Subject: ENERGY STAR® Program Requirements for Residential Windows, Doors, and Skylights  
– Version 6.0 Framework Document comments

The Window and Door Manufacturers Association (WDMA) would like to provide the following comments for consideration by EPA on the ENERGY STAR for Windows, Doors, and Skylights – Version 6.0 Product Specification Framework Document

US & Canada 4 Zone Energy Star

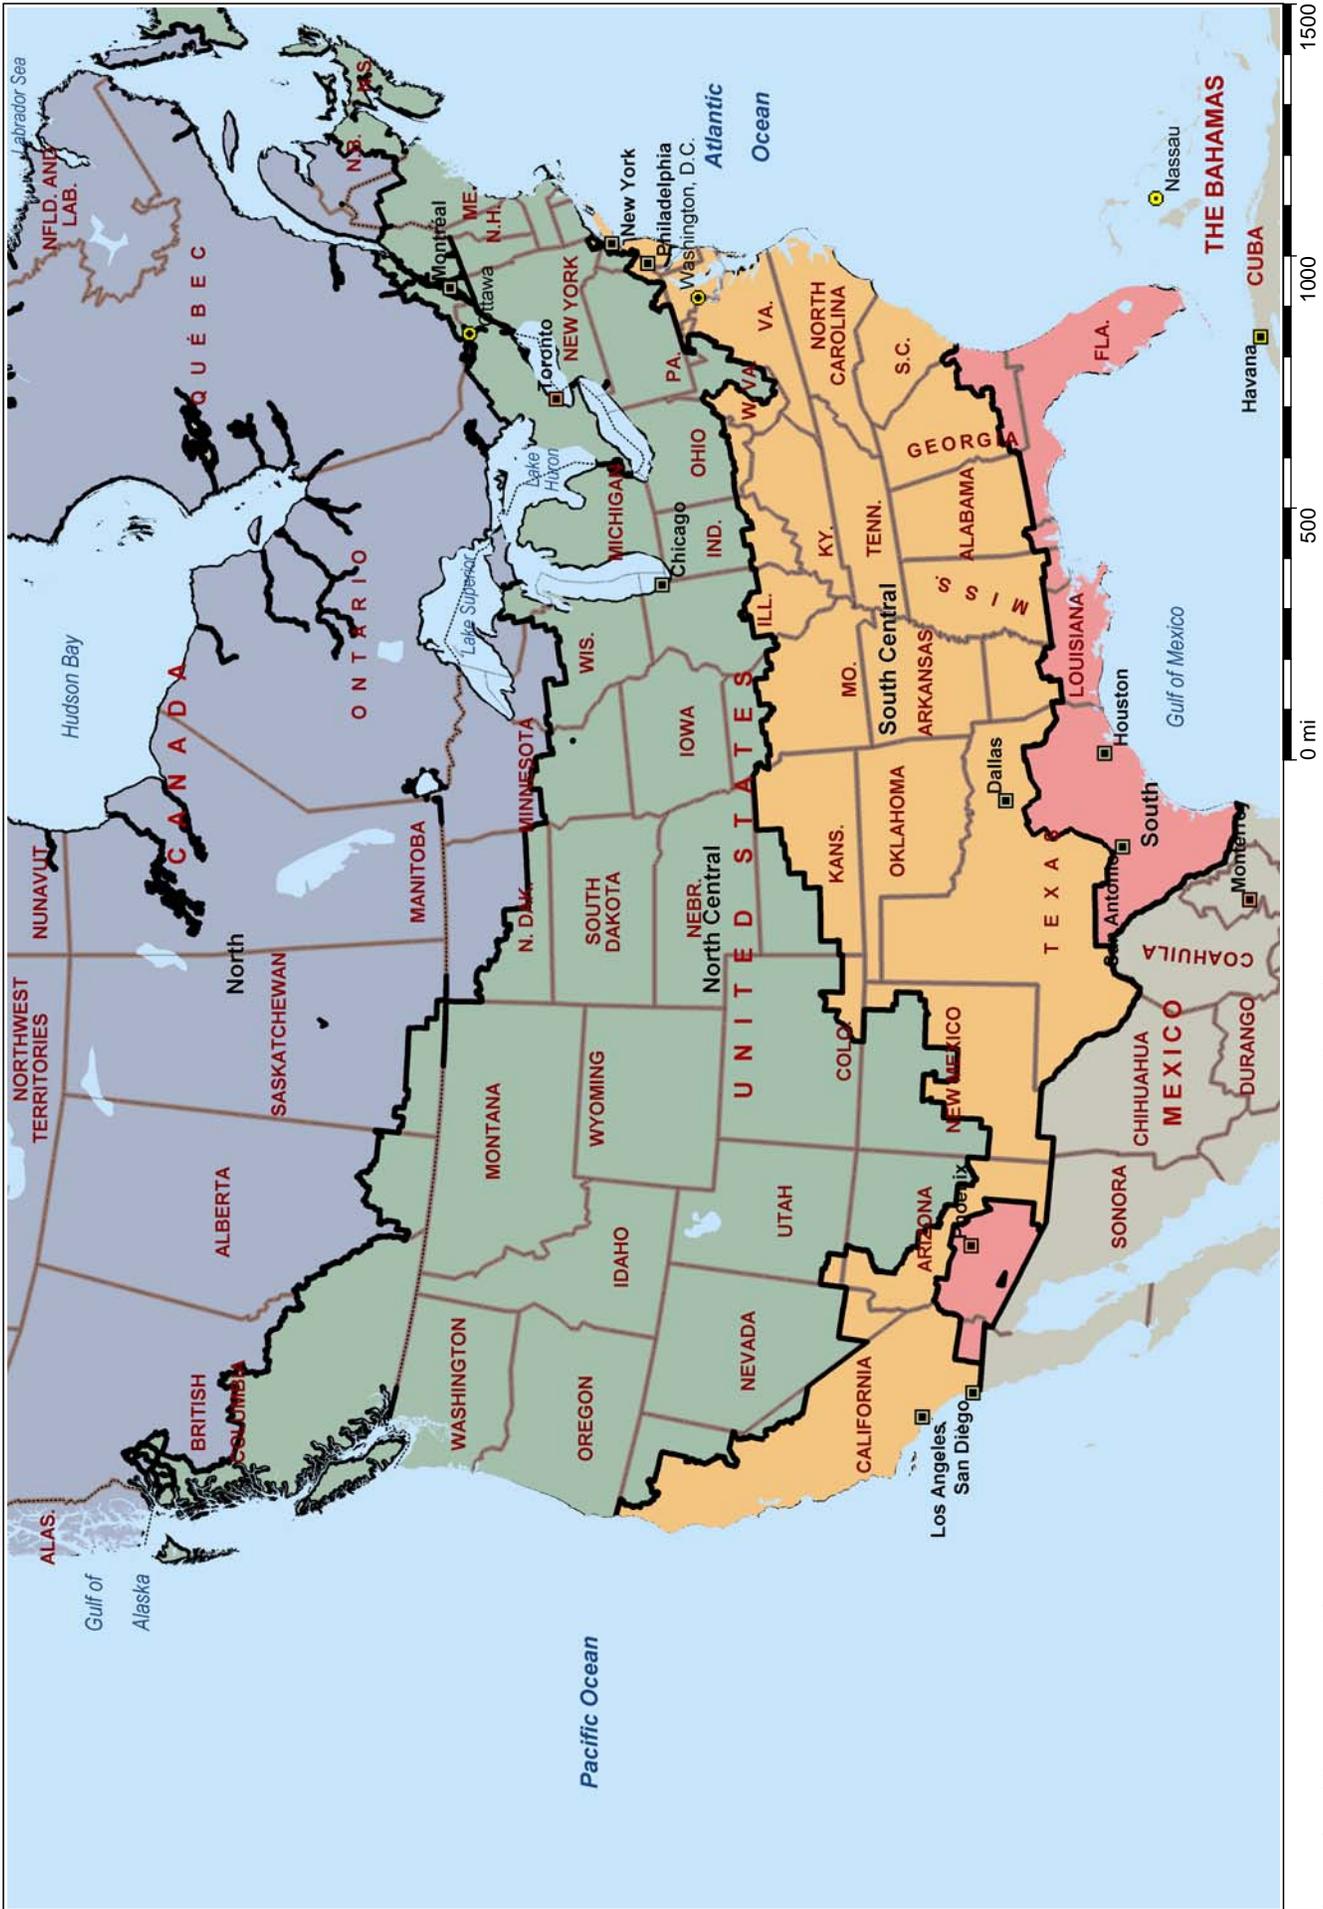
Specifically we are proposing that consideration be given to revising the climate zone map as follows:

- combine the South Central and North Central Zones into a new South Central Zone;
- maintain the current Northern Zone delineation but make it the North Central Zone; and,
- create a new Northern Zone that would incorporate the coldest climates in the northern U.S. and all of Canada

A proposed map delineating these zones is provided in Attachment A to these comments.
